# Access Compliance Report

## Public Rights-of-Way

### (Curb Ramps)

Intersection ID: 1002954	Main Street: HAZY_VALLEY_CT	Cross Street: N/A	Location: NE
ADA ID: 11EB295A4A33	Ramp Type: Perp	Initial Pass/Fail: Fail	Overall Compliance: No
Severity Score: 33.75			
Codes/Mitigation Info/Possible Solution		Field Measurements/Component Compliance

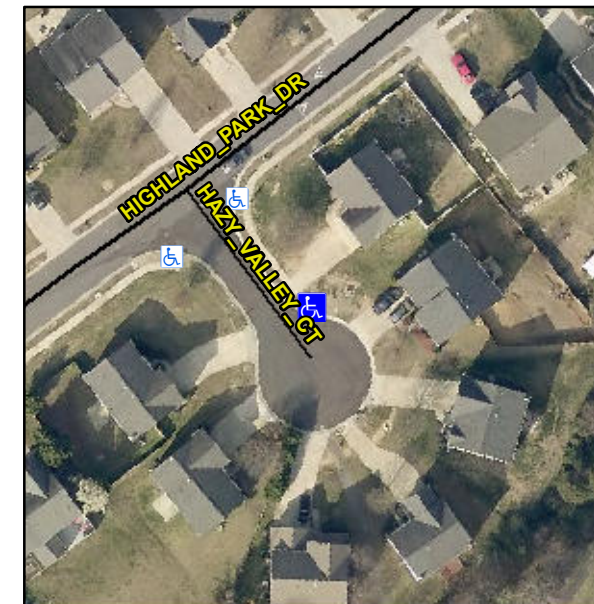
**Remove & Replace Entire Ramp.**

**R304.5.1, R304.2.2, R304.5.3**

Compliance	Description	Data	Compliance	Description	Data
N/A	Ramp Length (in)	46.5	No	Ramp Slope (%)	9.4
No	Ramp Width (in)	47.0	No	Ramp XSlope (%)	5.1
N/A	Flare Type LT	N/A	N/A	Flare Type RT	N/A
N/A	Flare Slope LT (%)	N/A	N/A	Flare Slope RT (%)	N/A
N/A	Flare Traversable LT?	N/A	N/A	Flare Traversable RT?	N/A
N/A	Landing Length (in)	N/A	N/A	DWS Provided?	N/A
N/A	Landing Width (in)	N/A	N/A	DWS Contrast?	N/A
N/A	Landing Slope (%)	N/A	N/A	DWS Length (in)	N/A
N/A	Landing X Slope (%)	N/A	N/A	DWS Full Width?	N/A
N/A	Landing Curb? (Y/N)	N/A	N/A	DWS Offset (in)	N/A
N/A	Shared Landing?	N/A			
N/A	Gutter Ponding?	N/A	N/A	Gutter Slope (%)	N/A
N/A	Gutter Lip Ht (in)	N/A	N/A	Gutter X Slope (%)	N/A
N/A	Painted X Walk1?	No	N/A	Painted X Walk2?	N/A
	X Walk 1 Direction	To SW		X Walk 2 Direction	N/A
N/A	X Walk 1 Width (in)	N/A	N/A	X Walk 2 Width (in)	N/A
	X Walk 1 Slope (%)	7.7		X Walk 2 Slope (%)	N/A
	X Walk 1 X Slope (%)	3.3		X Walk 2 X Slope (%)	N/A
